Safety Evaluation Report

related to the operation of
Midland Plant,
Units 1 and 2

Docket Nos. 50-329 and 50-330

Consumers Power Company

Figure 2.11 Locations of underground

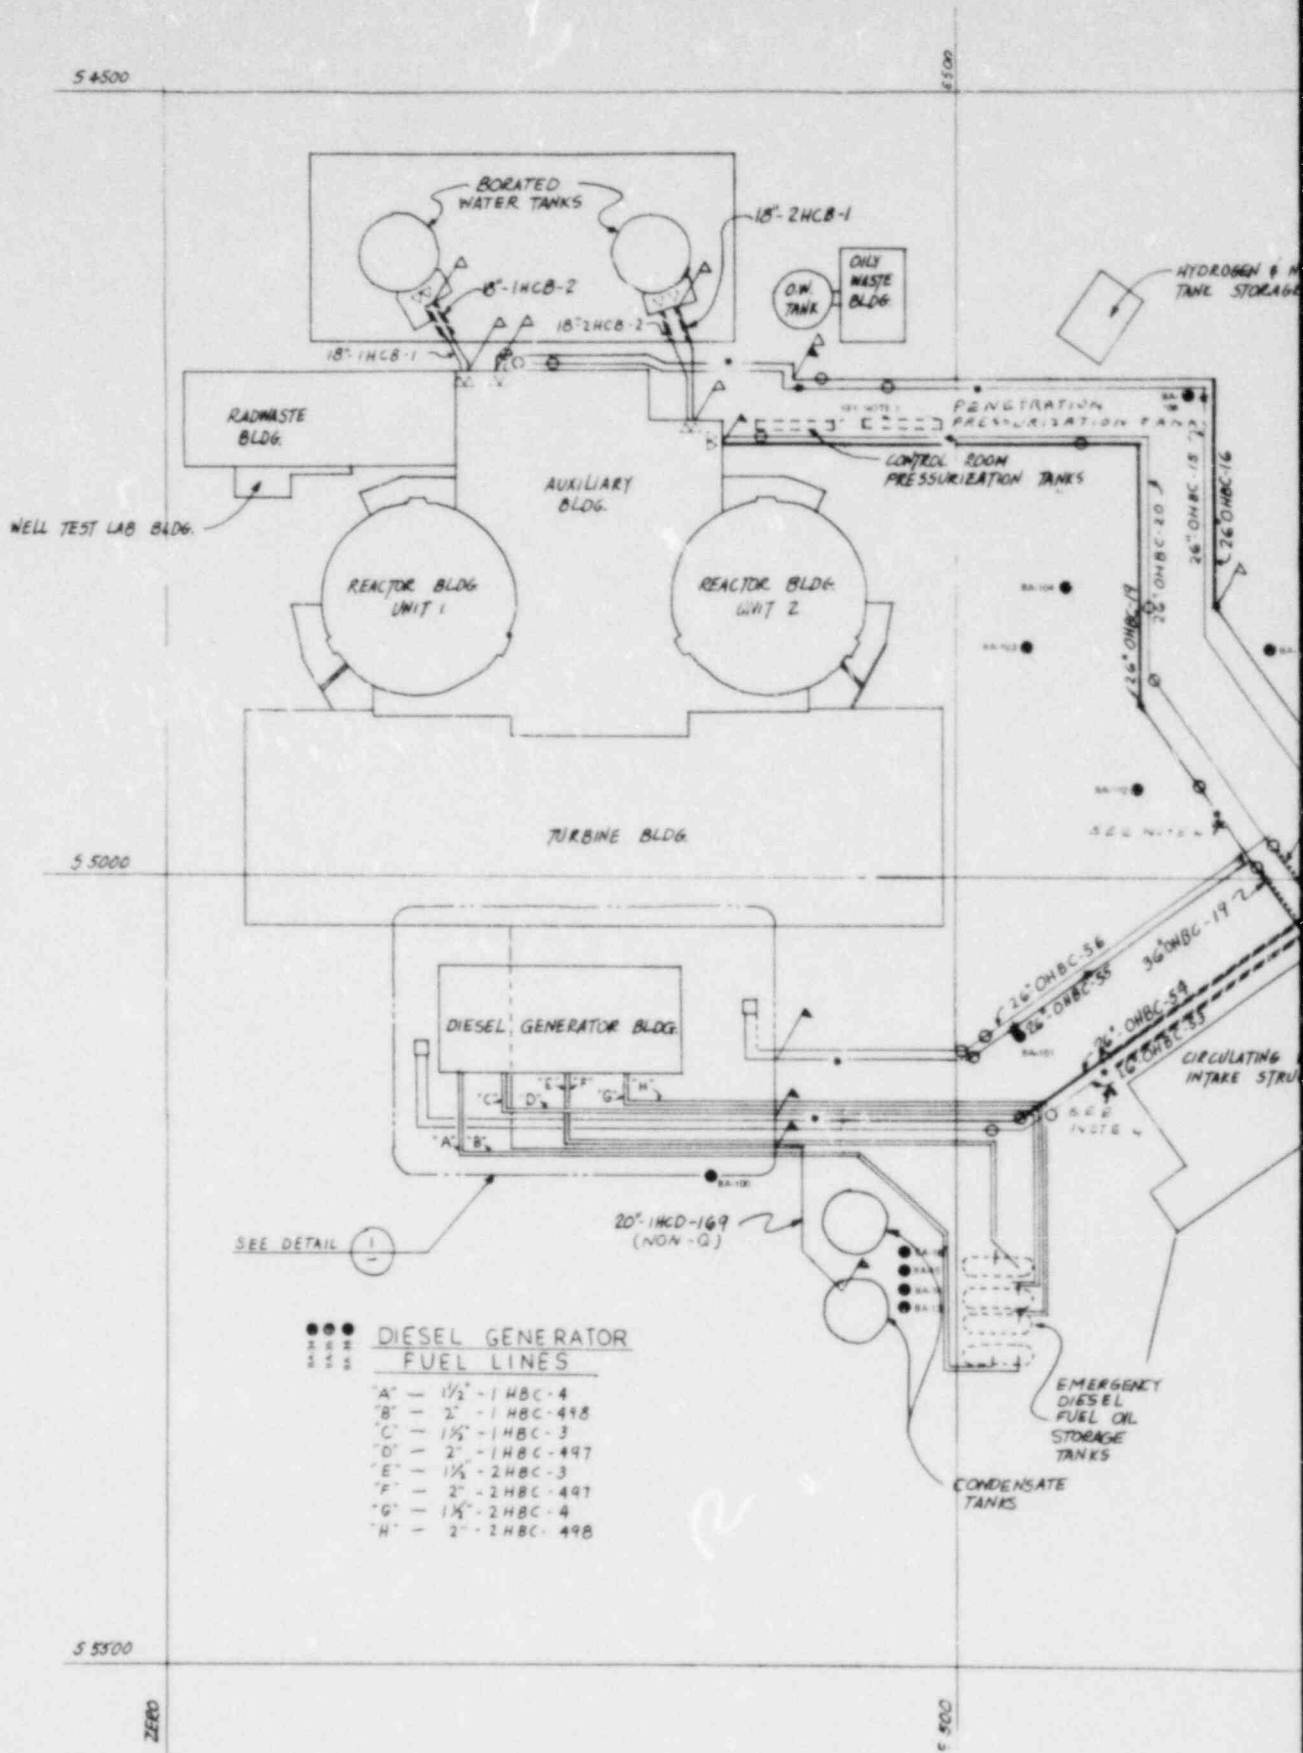
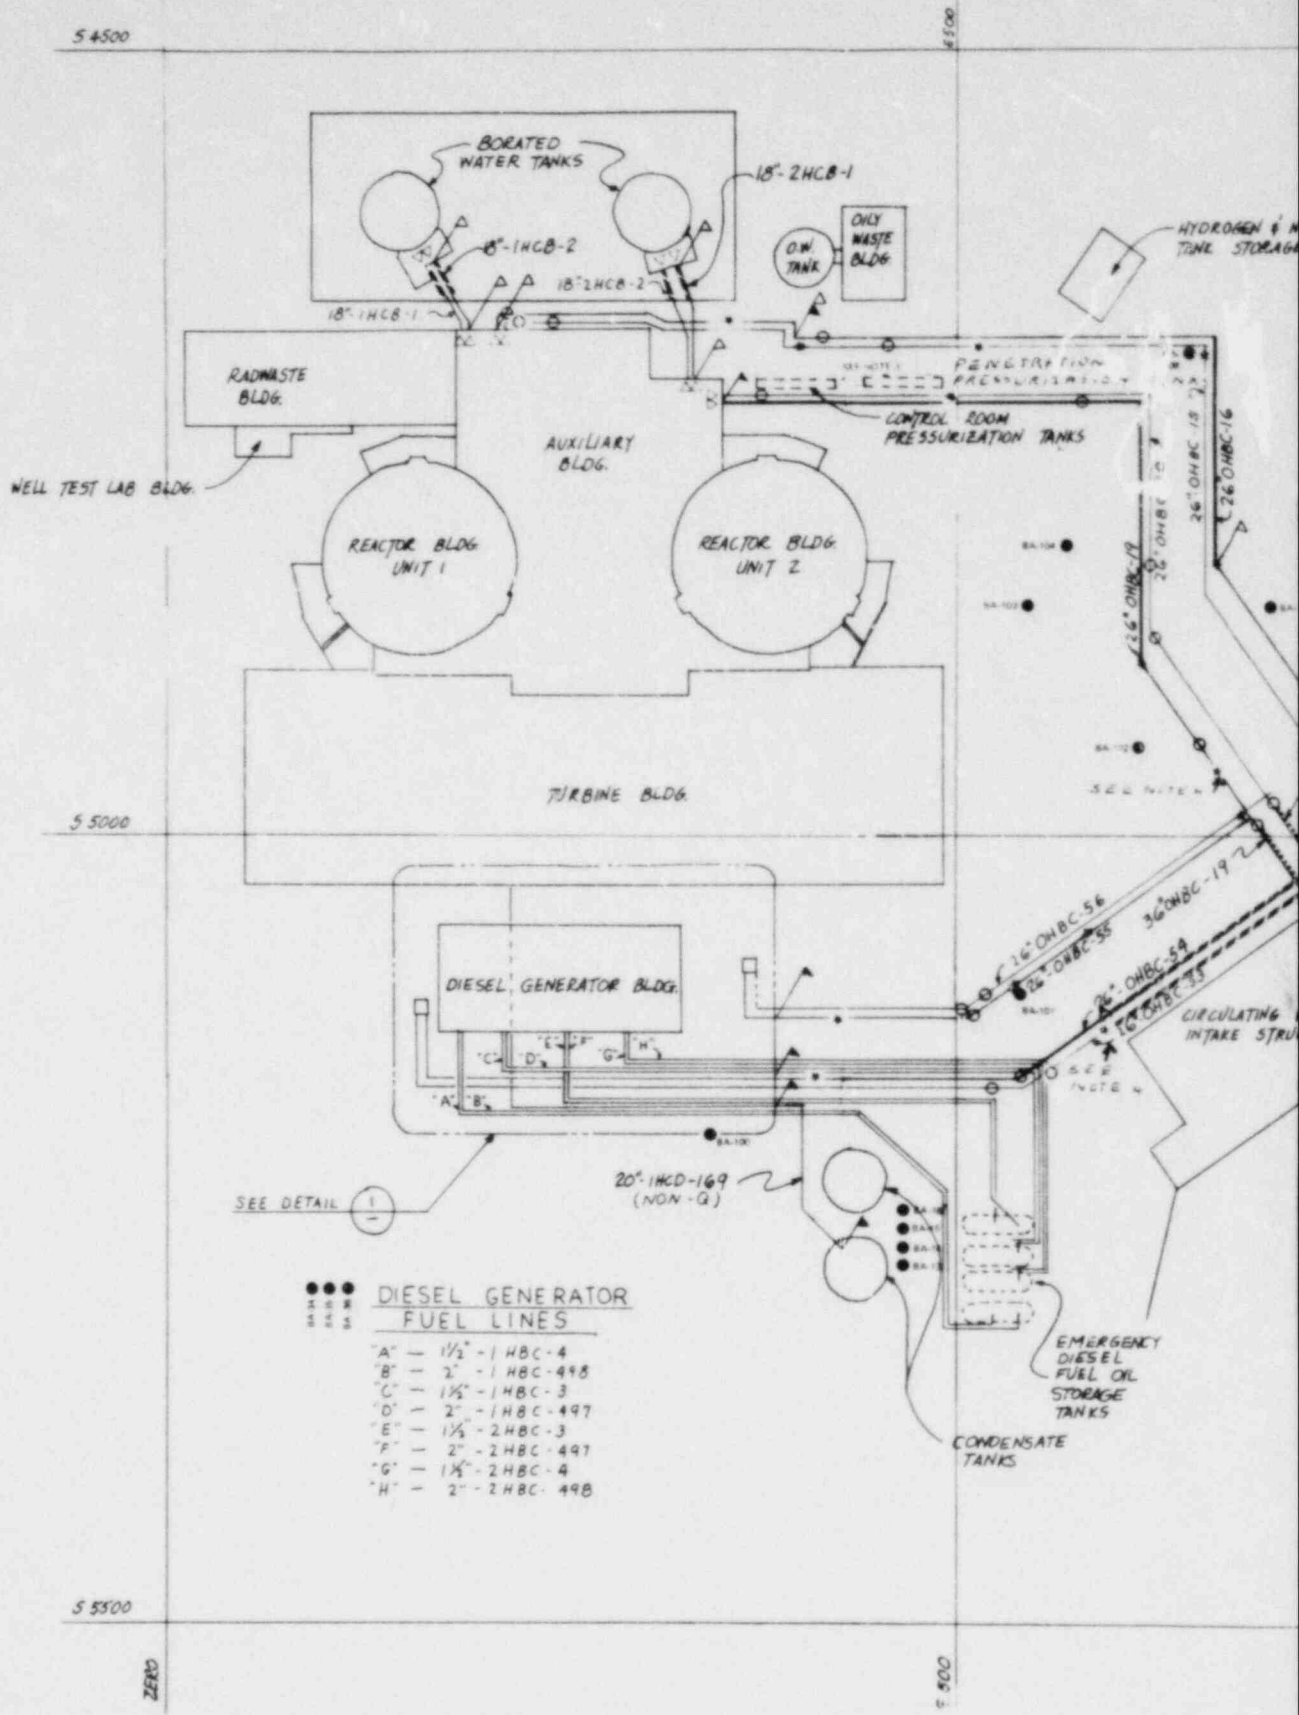
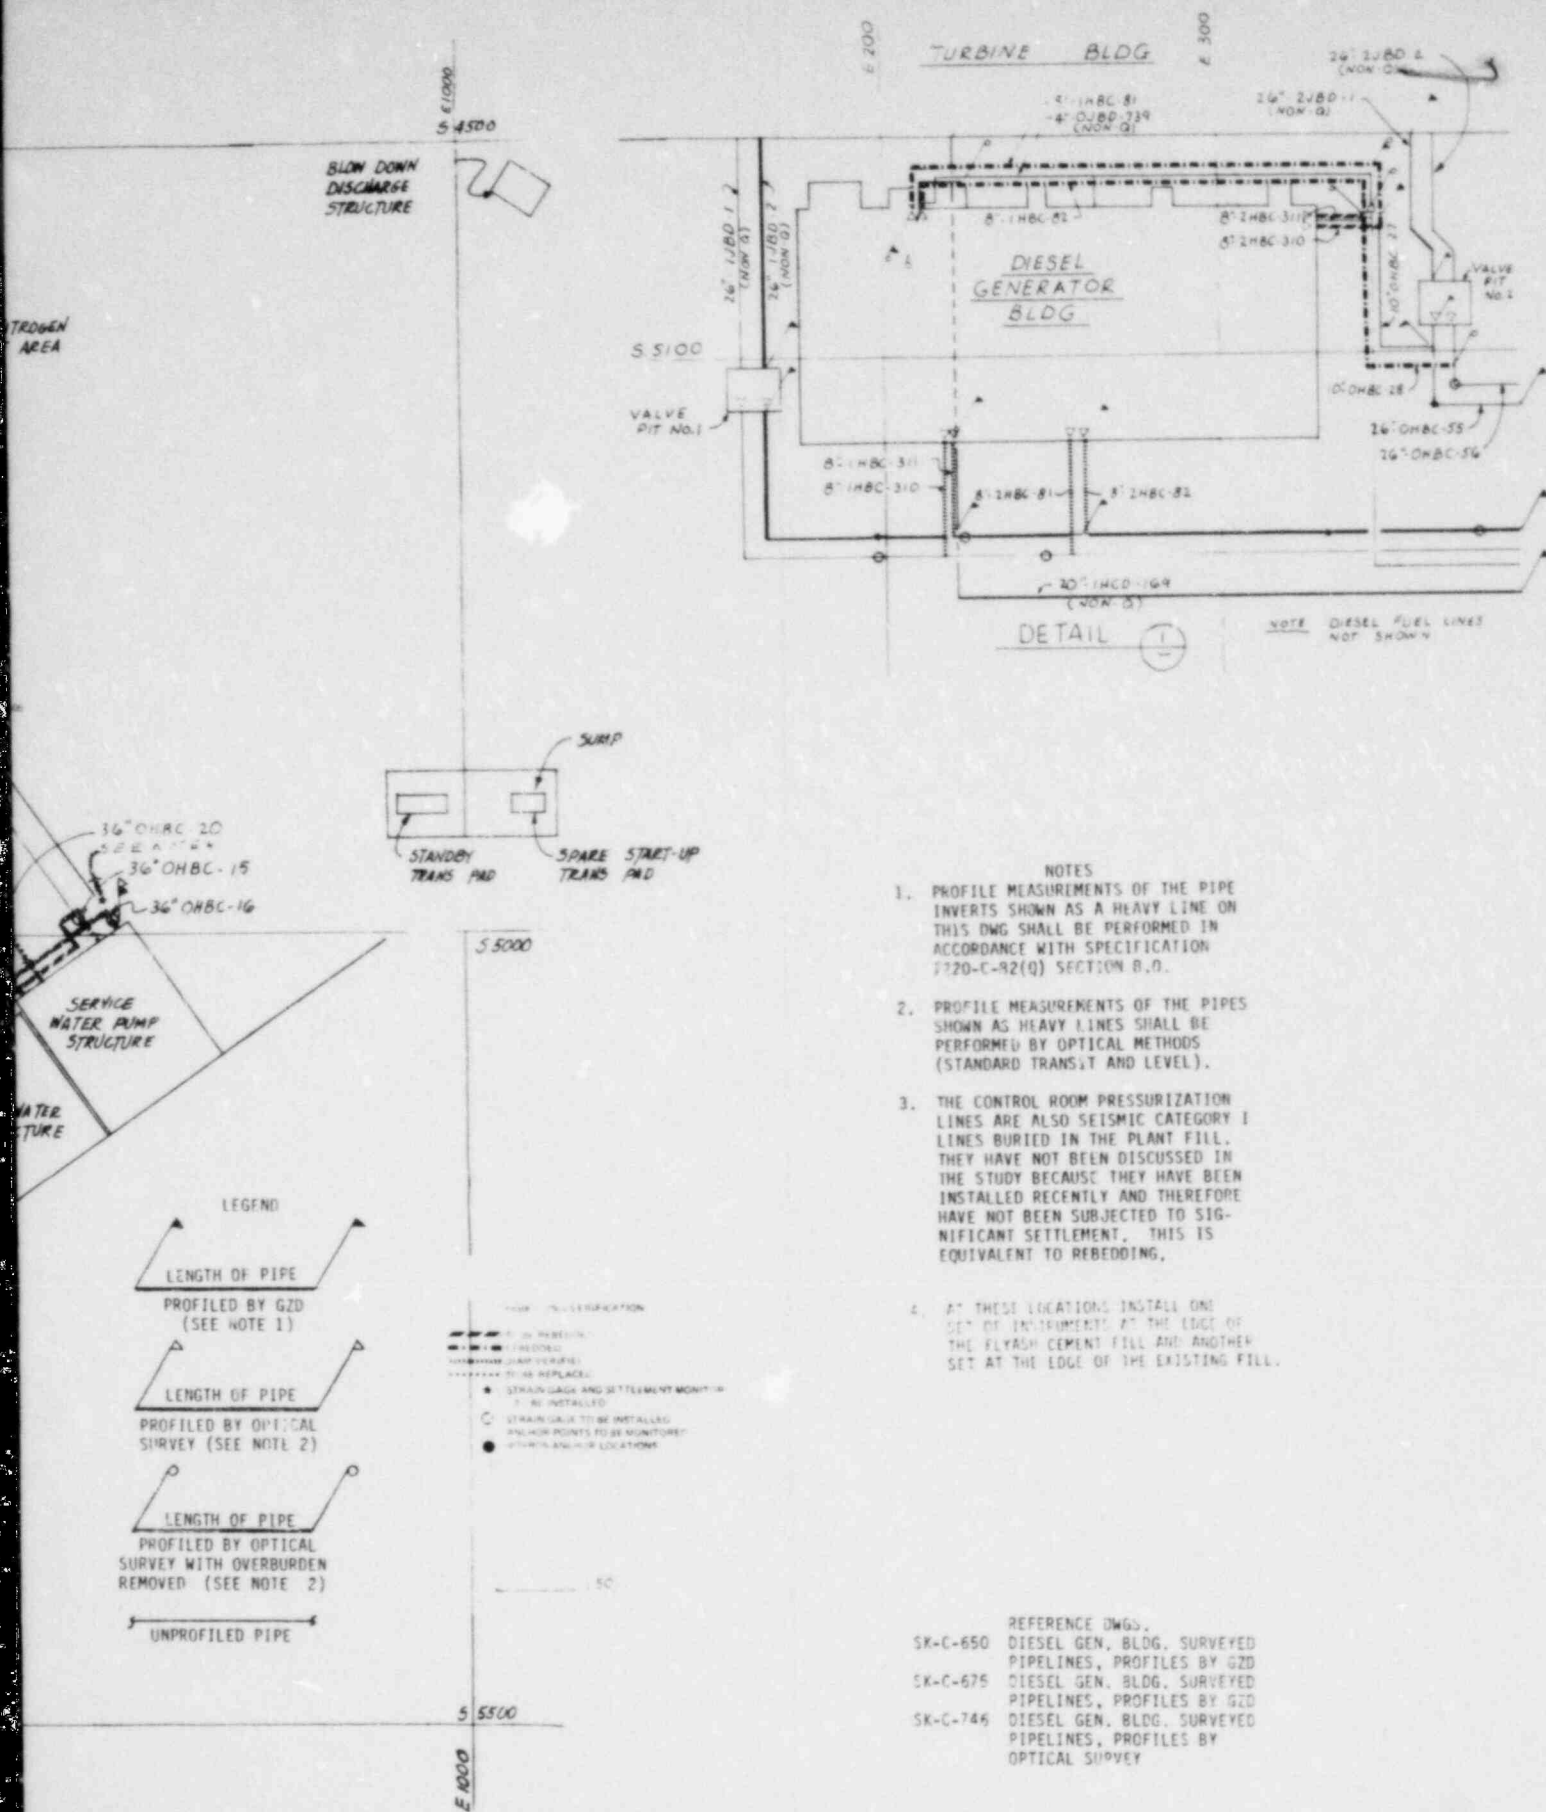
Concerns about differential settlement have been addressed by requiring the service water piping to be encircled with 6-in.-thick polyethylene planks that

are commercially named Ethafoam 220. The length of piping to be wrapped with this compressible product within the K-KRETE is 40 ft and spans from the portion of piping on the full depth of K-KRETE (to el 610 ft) to where it is supported on the existing clay fill soils. This transition length has been established in an analysis of pipe stresses where a 3-in. differential settlement over this length has been assumed and shown to be tolerable. These analyses are discussed in Section 3.9.3.1 of this SSER.

To verify that actual differential settlements do not exceed the assumed design values, the staff has required the placement of additional settlement markers at each end of the transition lengths at four locations, as shown on Figure 2.11 of this SSER. Discussions on future settlement monitoring of underground piping is presented in Section 2.5.4.6 of this supplement.

Figure 2.12 Conceptual view of instrumented underpinning pier
 (Source: Testimony of Edward M. Burke,
 W. Gene Corley, James P. Gould, Theodore E.
 Johnson, and Mete Sozen, Vol. 2, p. 5509,
 December 1, 1981)

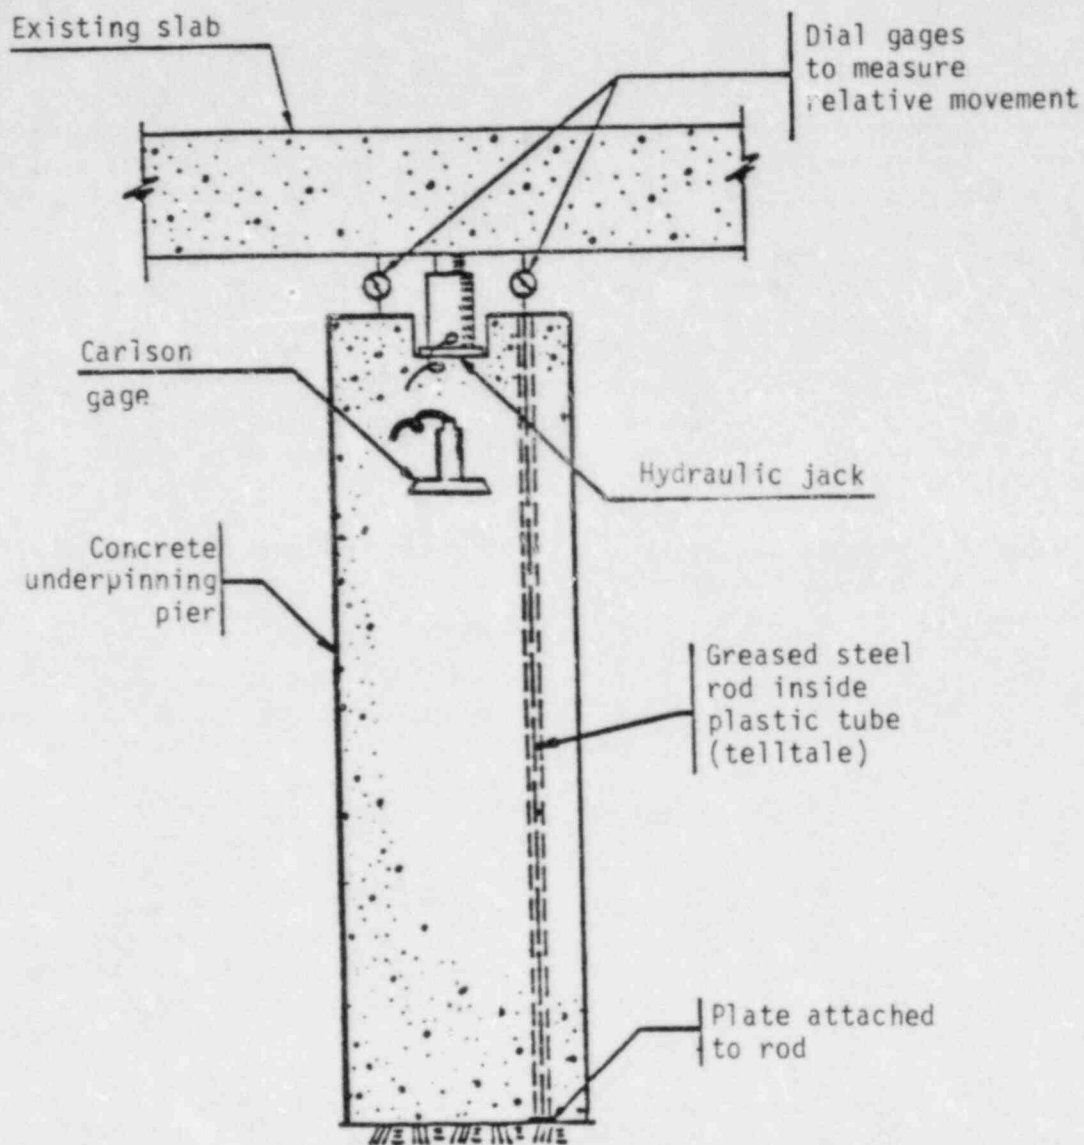
- (4) Settlement of some temporary and all permanent underpinning piers relative to superstructure, at top and bottom of piers: Dial gages and telltales. Reference: Figure 2.12 of this SSER.

- (5) Concrete stress in selected temporary and all permanent underpinning piers: Carlson stress meters near top and bottom. Reference: Figure 2.12 of this SSER.

Figure 2.13 Service water pump structure monitoring instrumentation
 (Source: Bechtel drawing 7720-SWPS-14)

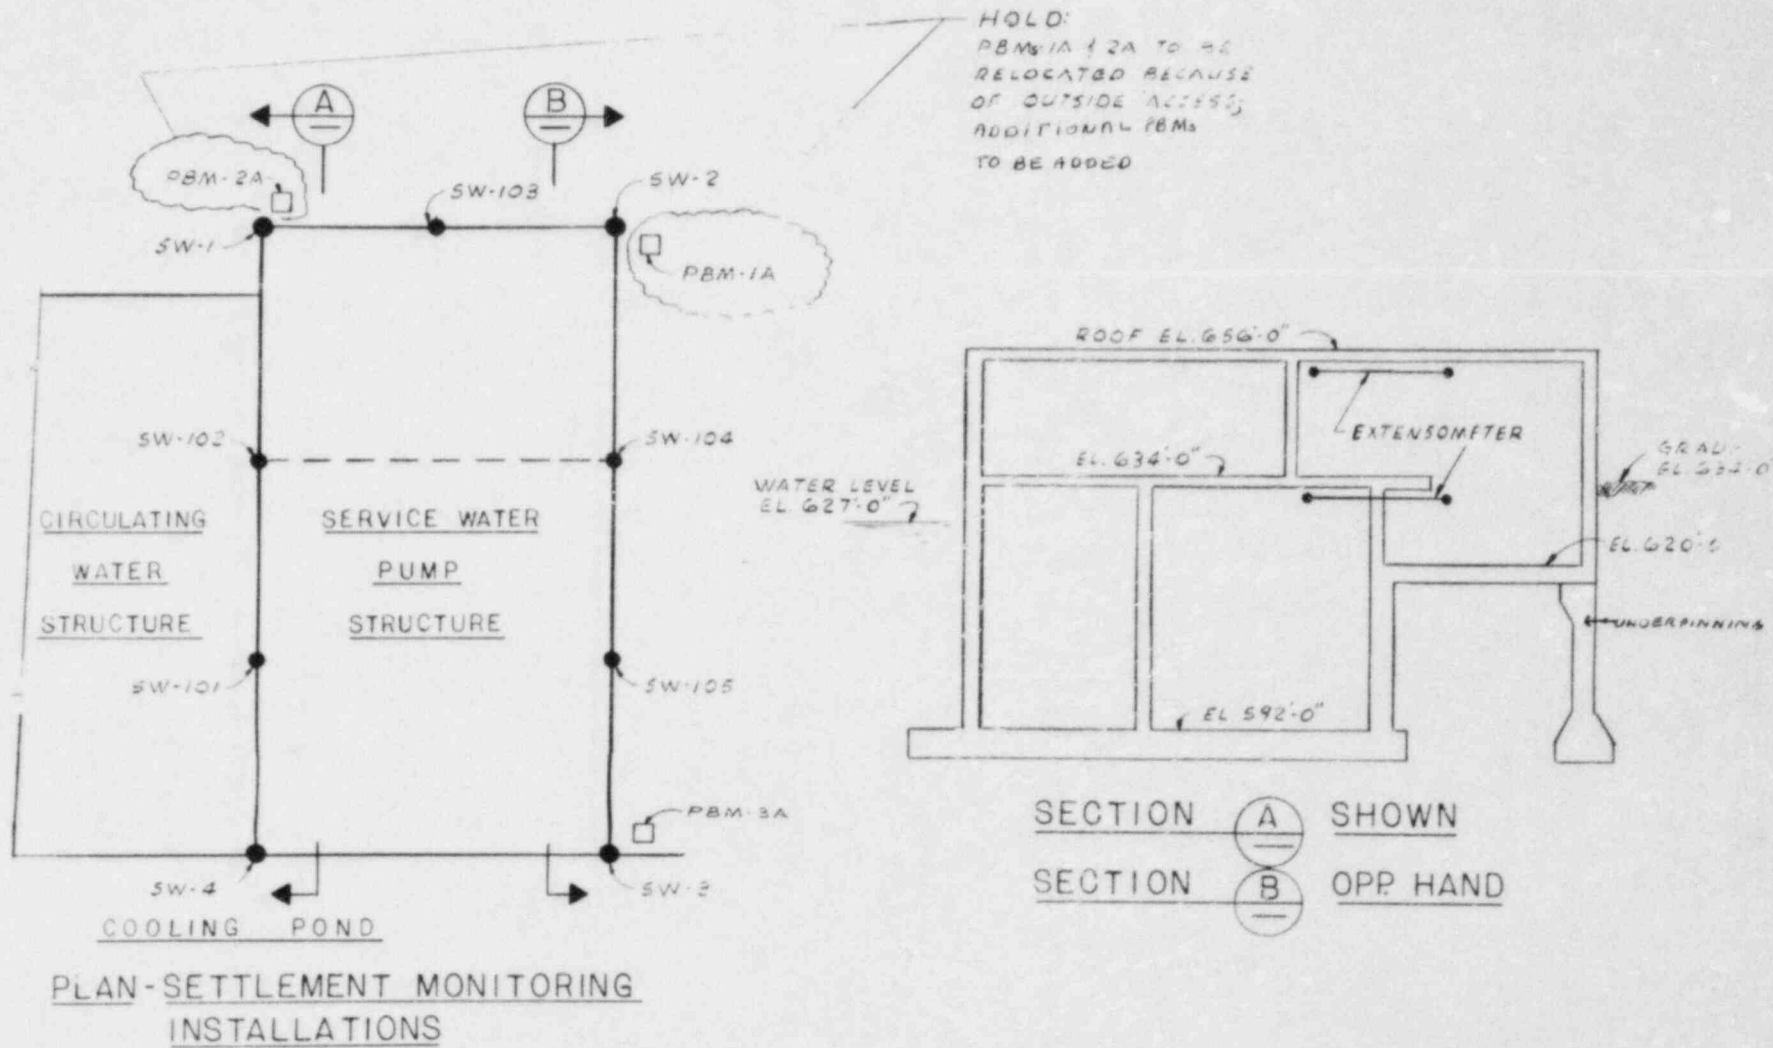
- (2) Strain of the concrete at critical locations near the intersection between the overhang and the deep portion: Four extensometers over a 20-ft length, each 5-ft long. References: Applicant's letter of April 19, 1982, p. III-9, and Figure 2.13 of this SSER.
